© 2016 Mazda Motor of America, Inc.

Subject: AIR TEMPERATURE WILL NOT CHANGE	Bulletin No: 07-003/16
	Last Issued: 09/28/2016

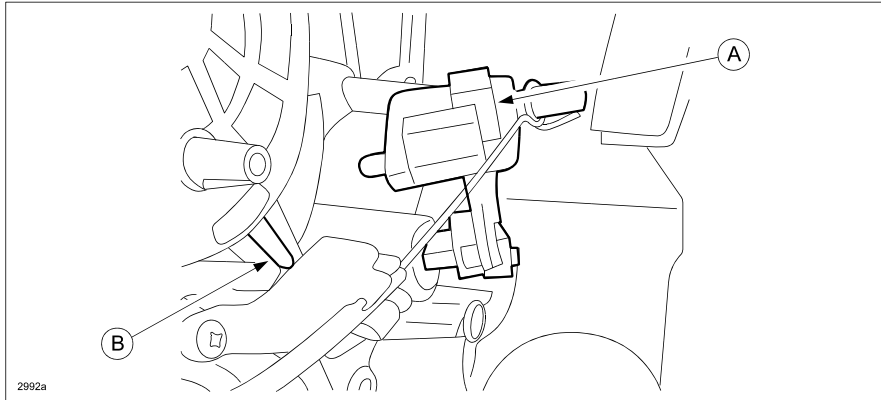
Some customers may complain that the air temperature from the air conditioner will not change with the air temperature control knob, and may be accompanied by some rattle noise from behind the dash board. This concern may be caused by the temperature control link being pulled out of the HVAC housing. To correct the problem, the temperature control link has been modified.

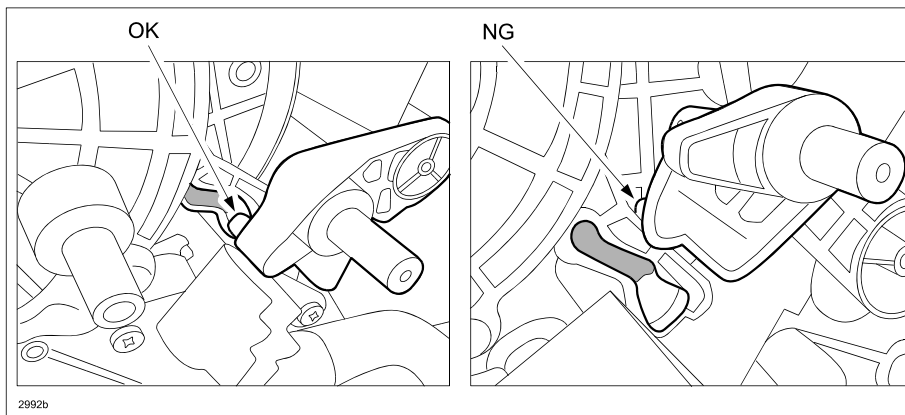
1. Verify customer concern.
2. Refer to the instructions on MS3 online or the Workshop Manual (section 07-40 CLIMATE CONTROL UNIT REMOVAL/INSTALLATION [MANUAL AIR CONDITIONER]) and check that the MIX LINK (Air mix link/Temperature control link) (A) is properly connected to the MIX DOOR CRANK (B) and works while rotating the temperature control knob.

- a. If it works, this Service Bulletin does not apply. Refer to the instructions on MS3 online or Workshop Manual for troubleshooting and repair.
 - b. If the MIX LINK is detached, proceed to the next step.
3. Japan built vehicles:
Replace the MIX LINK with a modified one. Refer to MS3 online (A/C UNIT DISASSEMBLY/ASSEMBLY). Make sure that the MIX LINK is fitted in the groove of the MIX DOOR CRANK and will not come out with movement.
